PLANNING & INSPECTIONS DEPARTMENT
Craig N. Benedict, AICP, Director

August 31, 2020

**RE: REVIEW of Conditional Zoning Atlas Amendment – Master Plan Development (MPD) for
STAFF INITIAL REVIEW COMMENTS**

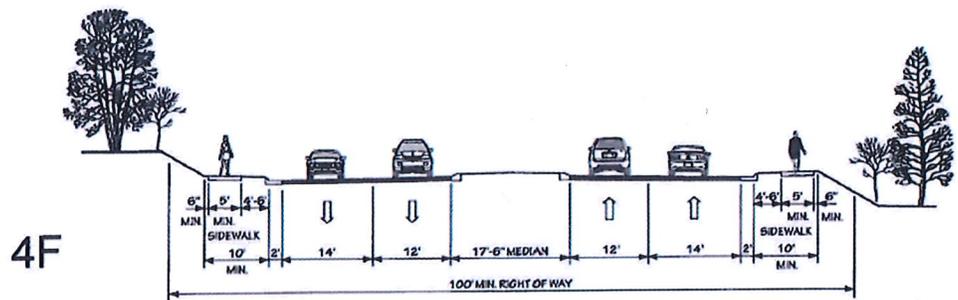
- D. Staff is concerned about the proposed drive access points along the Interstate exit ramp running parallel with the southern Property line.

Specifically, staff is concerned about what appears to be 2-way traffic access onto the exit ramp from Development Area 1 (i.e. Buc-ee's Travel center).

Staff will be recommending to the applicant and NC DOT the proposal be revised to allow for right-turn only for these driveways, specifically:

- Entrance to the Project near the intersection of Mt. Willing Road;
- Exit onto the allowing drivers to access Development Area 1 near the intersection of the UD Highway 70 connector.

This presumes NC DOT allows for the development of driveway/access roads onto the exit ramp serving Development Area 1.

4 LANE DIVIDED (17'-6" RAISED MEDIAN) WITH CURB & GUTTER,
WIDE OUTSIDE LANES, AND SIDEWALKS
POSTED SPEED 35-45 MPH

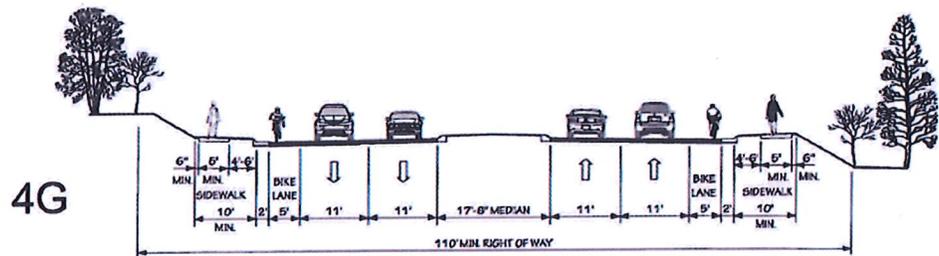
- F. Mt. Willing Road is on the County's adopted 2019 *Efland-Buckhorn-Mebane Access Management Plan* (EBM AMP) as well as the Orange County CTP. Staff will be recommending the incorporation of the following:

- i. 4-Lane divided cross section (*page 20* of the EBM AMP)
- ii. The current right-of-way for Mt. Willing Road is 60 ft. Staff is recommending a 25' reservation of additional right-of-way along the western boundary of the Property in support of future improvements along the roadway.
- iii. Staff will be requiring a 100 right-of-way (4F) or 110' right-of-way (4G) – NOTE: sample cross sections on next page;
- iv. County staff will recommend to the BOCC that Mt. Willing Road improvements be approved as a County priority in SPOT 7 and subsequent processes.
